Westinghouse
Electric Corporation

NTD-NRC-96-4630
DCP/NRC0453
Docket No: STN-52-003

SUBJECT: WESTINGHOUSE RESPONSES TO NRC REQUESTS FOR ADDITIONAL
INFORMATION ON THE AP600

NRC REQUEST FOR ADDITIONAL INFORMATION

Question 440.482

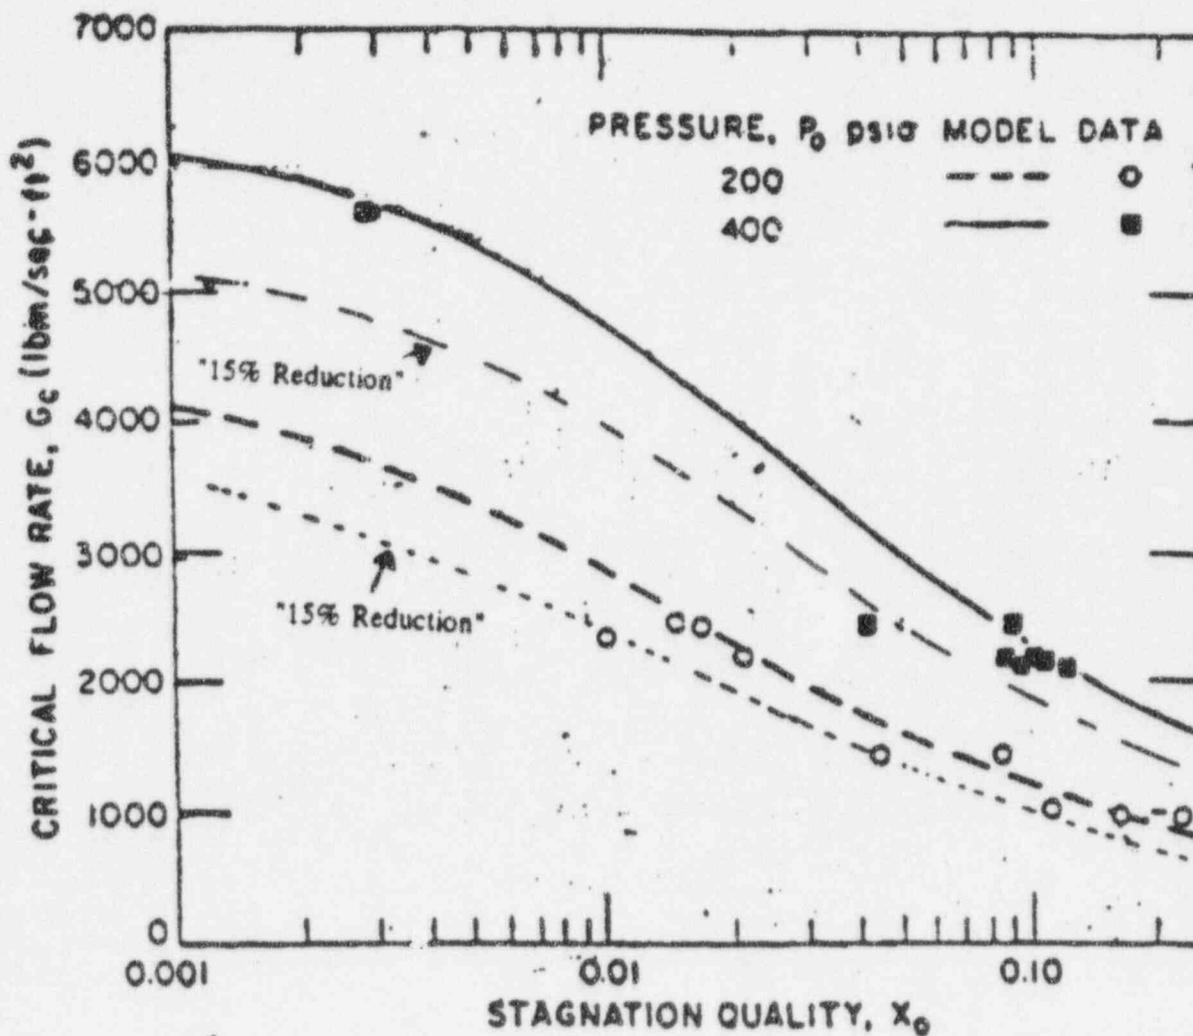
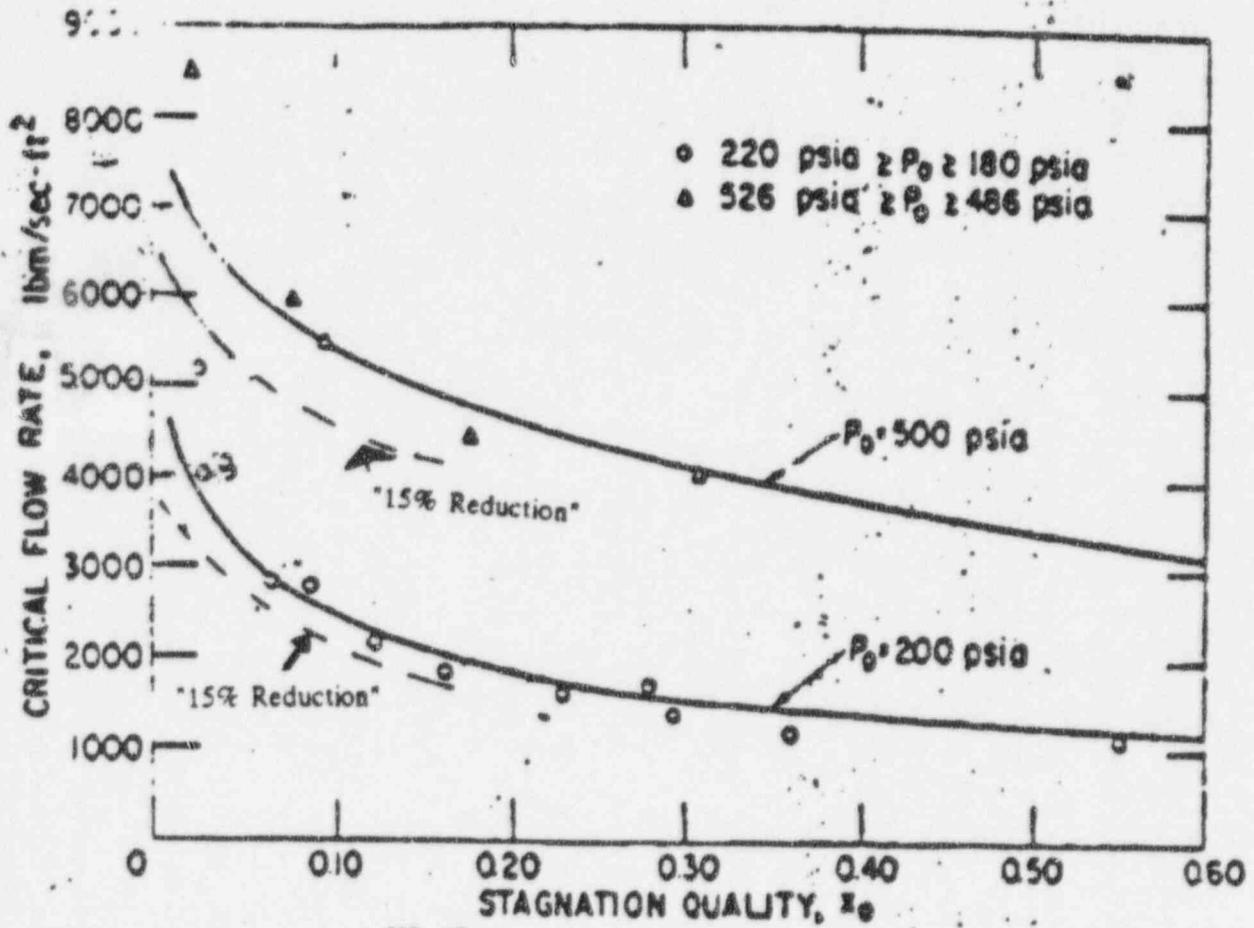
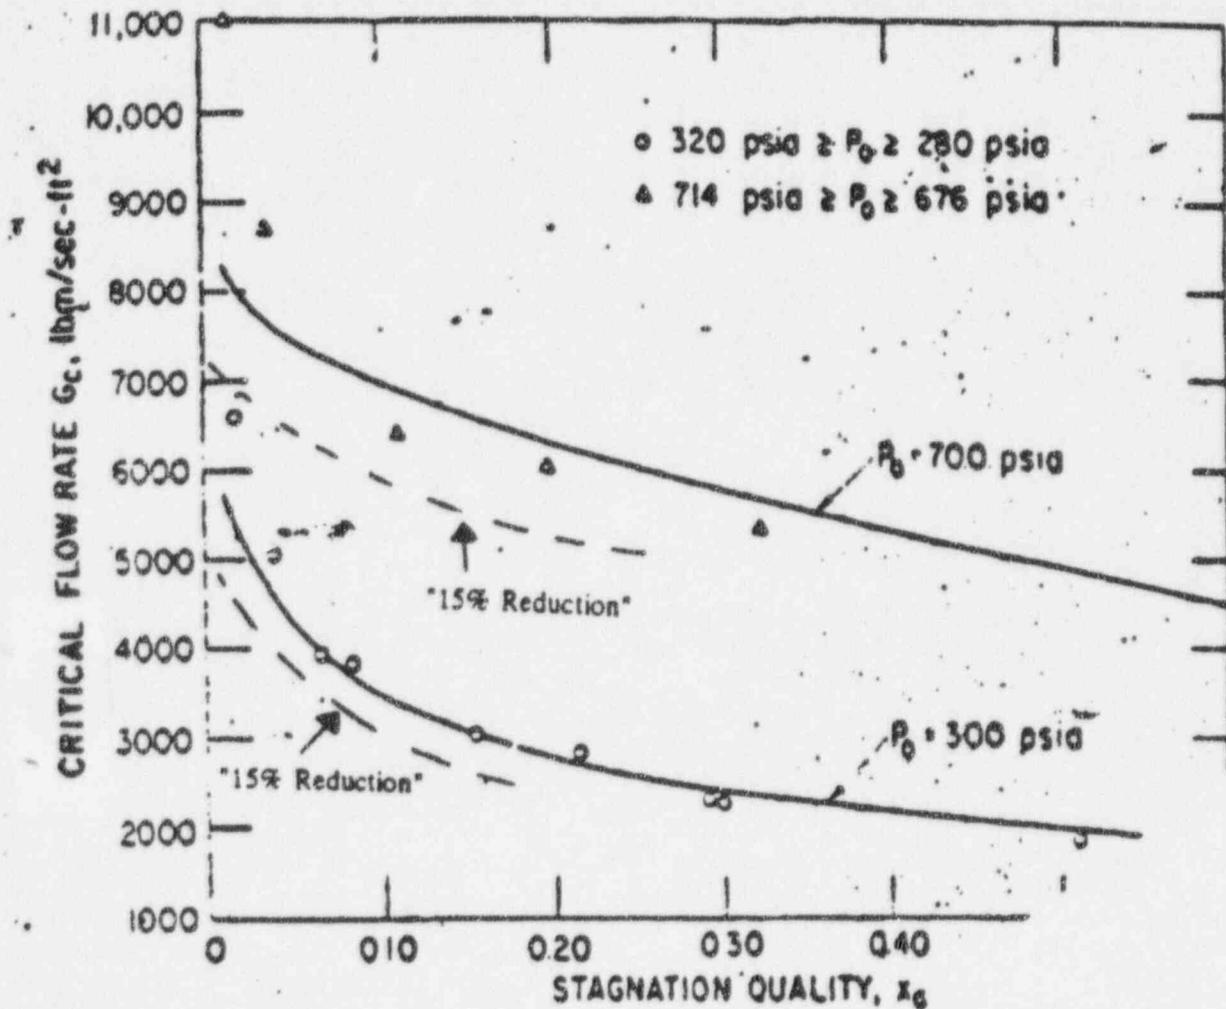
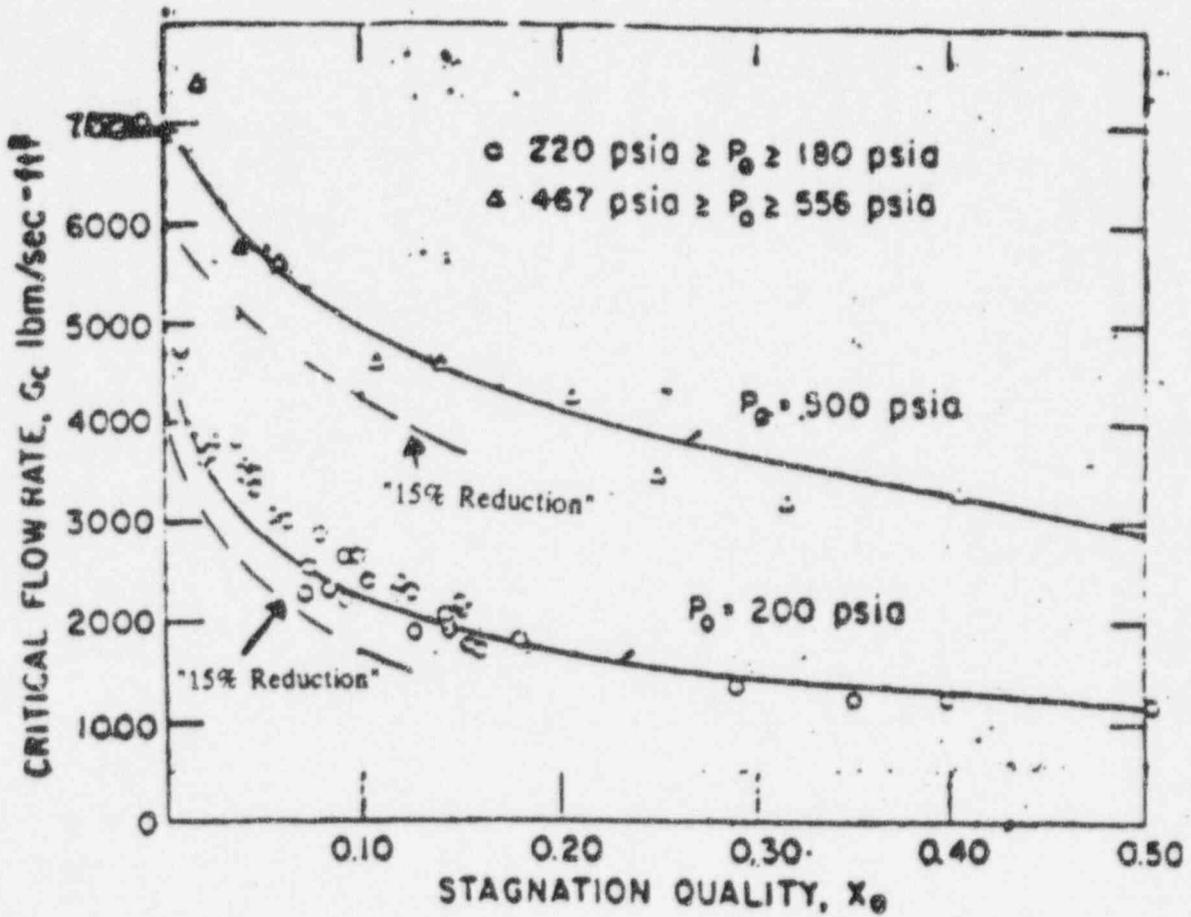
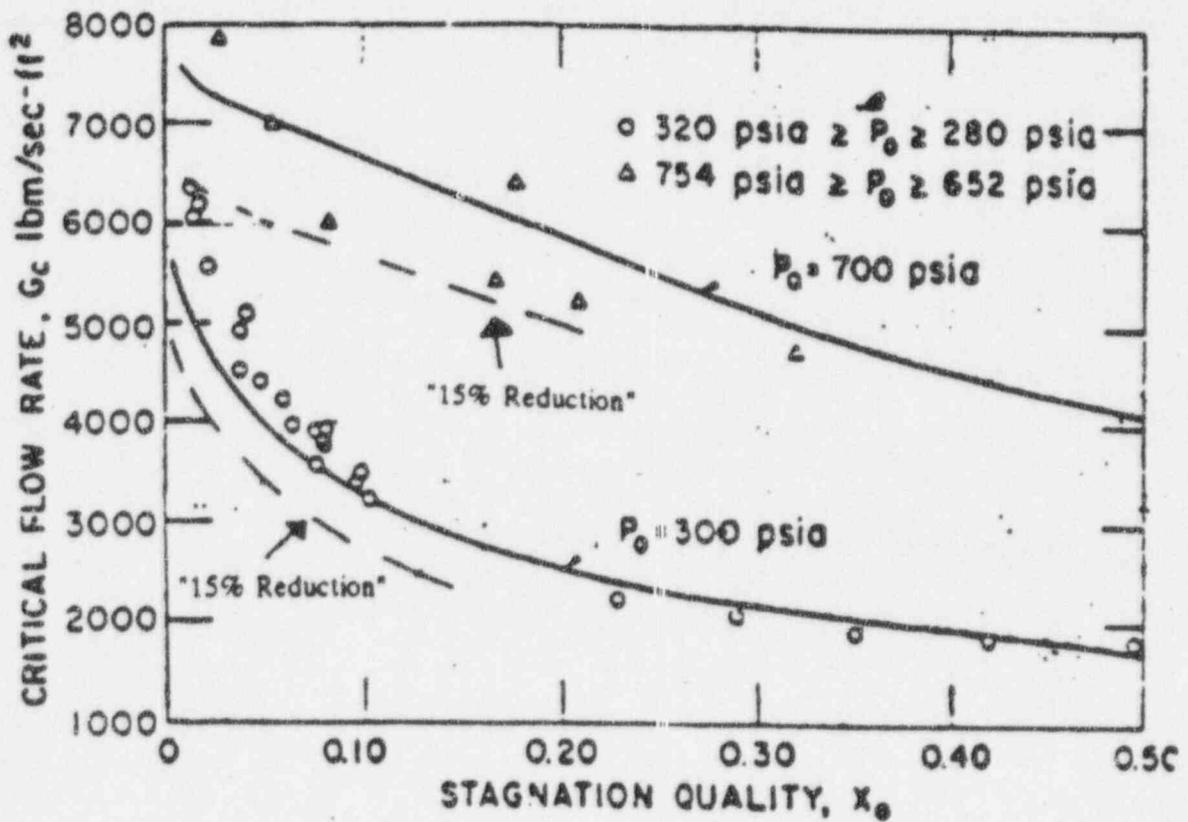
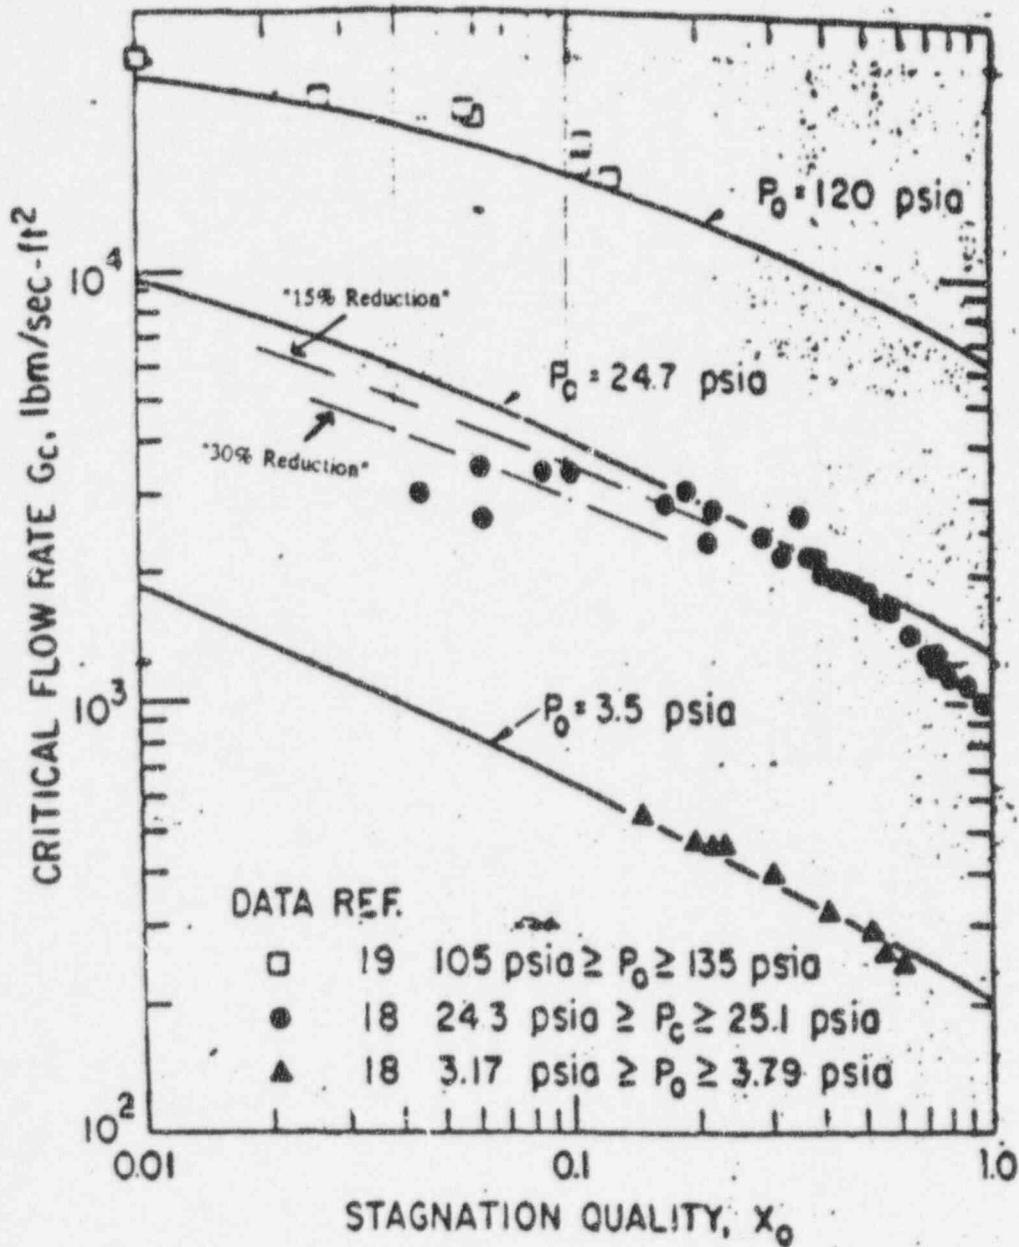
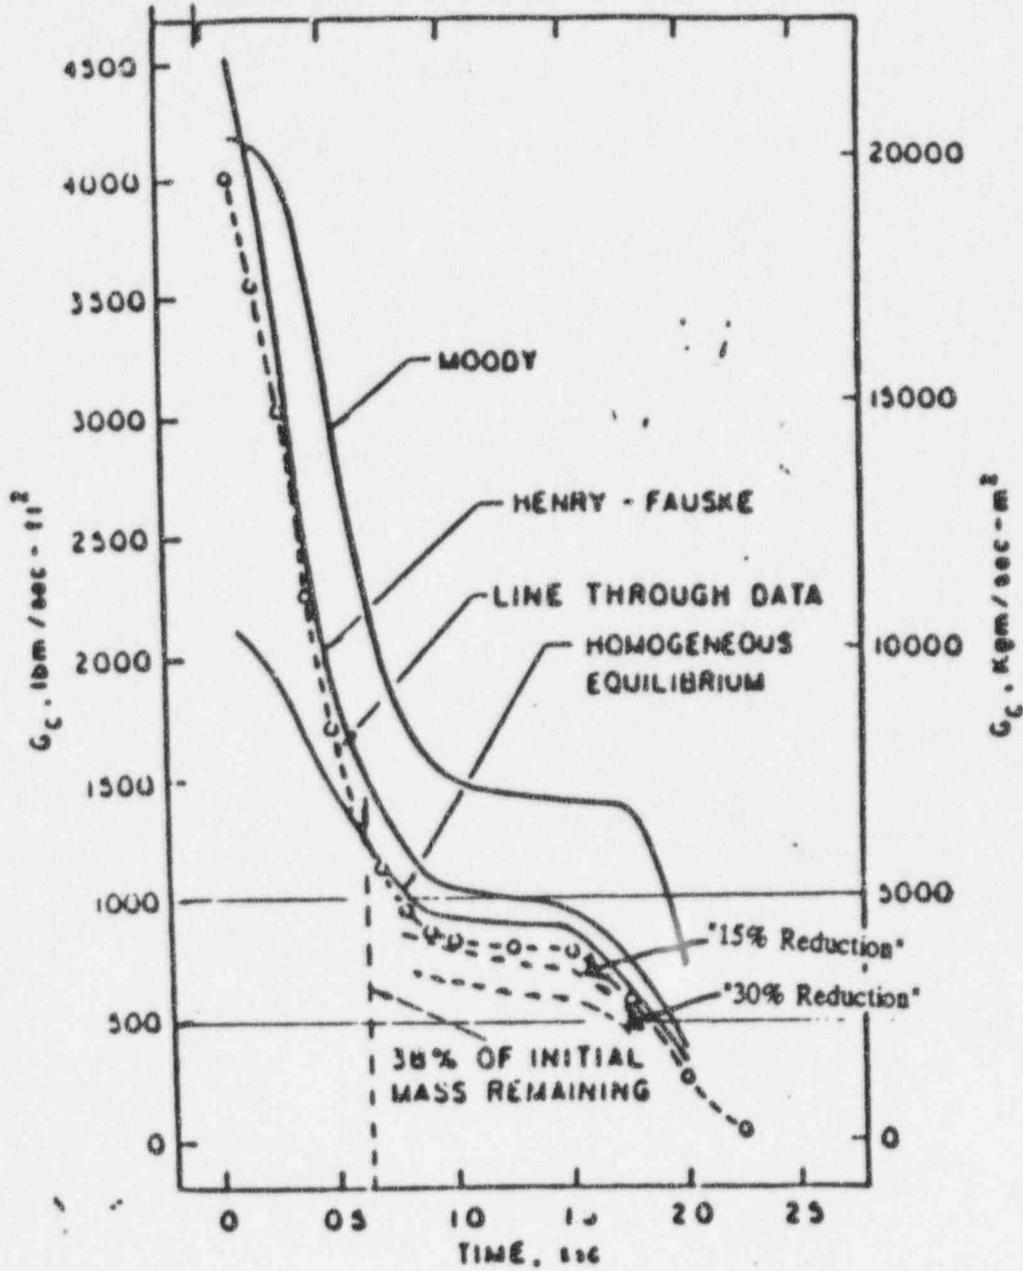
440.482 Please provide benchmark of the new critical flow model versus critical flow tests to justify and verify the coding changes. Also, please describe the model for unchoked conditions and explain how the model treats the transition from choked to unchoked conditions. Consider selected Marviken critical flow data for verifying the NOTRUMP code's ability to simulate subcooled, saturated two-phase, and single phase steam discharge.

The validity of these two models was assessed in the response to RAI 952.95 which documented the ADS 4 valve area sensitivity study. RAI 952.95 examined the uncertainty in the critical flow from these two models to assess the margin in the ADS stage 4 valves. The uncertainty was typically found to be approximately 15% for the models over a range of pressures and inlet enthalpies for different tests. Comparisons were taken from the literature as well as the original papers. Figures 440.482-1 to 440.482-6 were taken from Reference 440.482-2 for the Henry/Fauske model for the subcooled and low quality portion of the flow. The references given in the figure titles refer to the references given in Reference 440.482-2. The figures show the agreement of the Henry/Fauske correlation for difference sets of data and different fluids. Superimposed on these figures are the model predictions multiplied by 0.85 and/or 0.7 to indicate a 15% to 30% uncertainty of the model relative to the data. As the figures indicate, the Henry/Fauske model agrees very well with the data, usually within 15%.

Similar plots for the HEM model are given in Figures 440.482-7 to 440.482-9 from references 440.482-2 and 440.482-3. As the figures indicate, the HEM model agrees within 15% for the data shown.

The data comparisons given in Figures 440.482-1 to 440.482-7 do not cover the full pressure range for the AP600 small-break LOCA, but rather cover the low pressure portion of the transient. The NOTRUMP SPES and OSU comparisons provided in the preliminary validation reports provide additional validation over the higher pressure range from 2250 psia down to 140 psia which overlaps with the data comparisons given in Figures 440.482-1 to 440.482-9. The method used for the SPES and OSU comparisons to the NOTRUMP predictions with the Henry/Fauske - HEM critical flow model was to use the integrated flow measurements from the beginning of the test, until the ADS stage 1 valve opened. The integrated flow (lbms) was divided by the time to reach ADS stage 1 to obtain an average mass flowrate out the break. The earlier of either the data or the prediction was used for the ADS stage 1 opening time for a given test. By using the integrated break flow data over this time period, the only flow path out of the system was through the break. Also, by selecting the time period before ADS stage 1, the additional complications of timing differences between the code and the data and a more complex mass distribution within the primary system are avoided. Figure 440.482-10 shows the comparison of the average break flow predicted by the NOTRUMP code and the measured average flow rate. Figure 440.482-11 shows the ratio of the measured flowrate to the predicted flowrate for the different tests. Both figures indicate that the combined Henry/Fauske - HEM model represents the critical flow with the similar uncertainties as the comparisons with the original data. The poorest comparison was the tests SB10, the double-ended cold line balance line break. If the measured-to-predicted
